QDR-5437-241-01

QUALIFICATION REVIEW PACKAGE

ROSEMOUNT TRANSMITTERS.

Subject: Surry Unit 2 Transmittal of Qualification
Review Package No. QDR-5437-241-01 for
TMI Item, Rosemount Transmitters

FIGURE 3

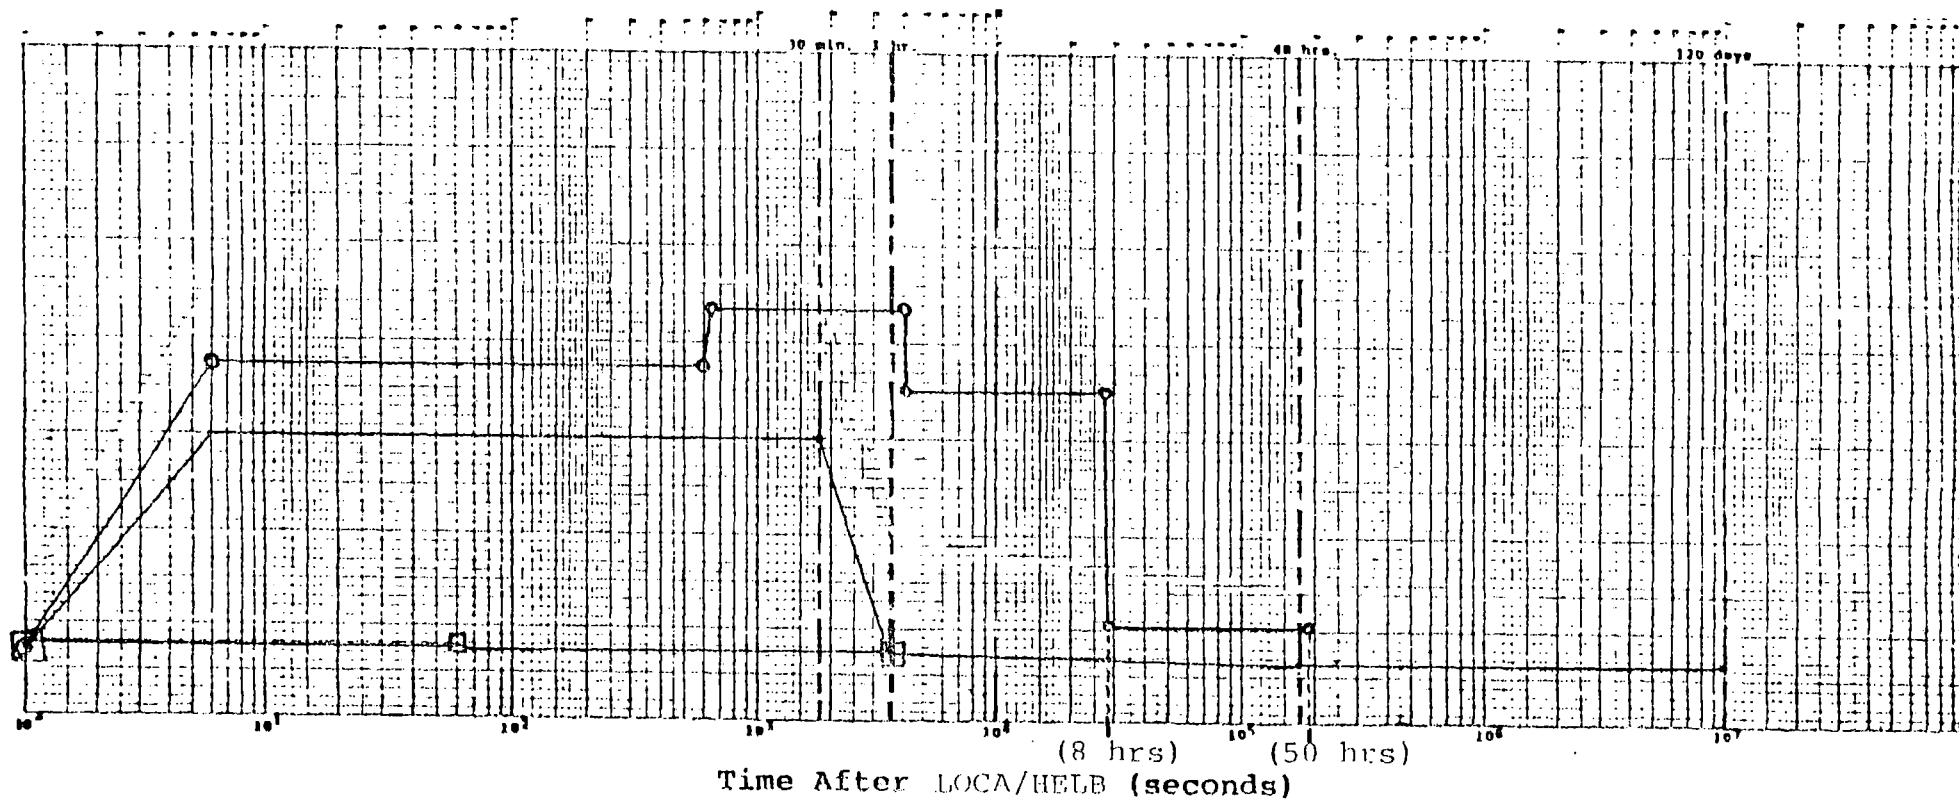
As shown in Figures 3 & 3A Rosemount conducted a steam pressure test for 50 hours (Sec. 5.5 of Ref. report no. 6) which envelops the required one hour plant HELB conditions. Hence the conducted test is considered more severe and the transmitters are qualified for HELB conditions.

In the following calculations the first one hour (See fig. 3) of the test which envelops the plant HELB conditions is not considered.
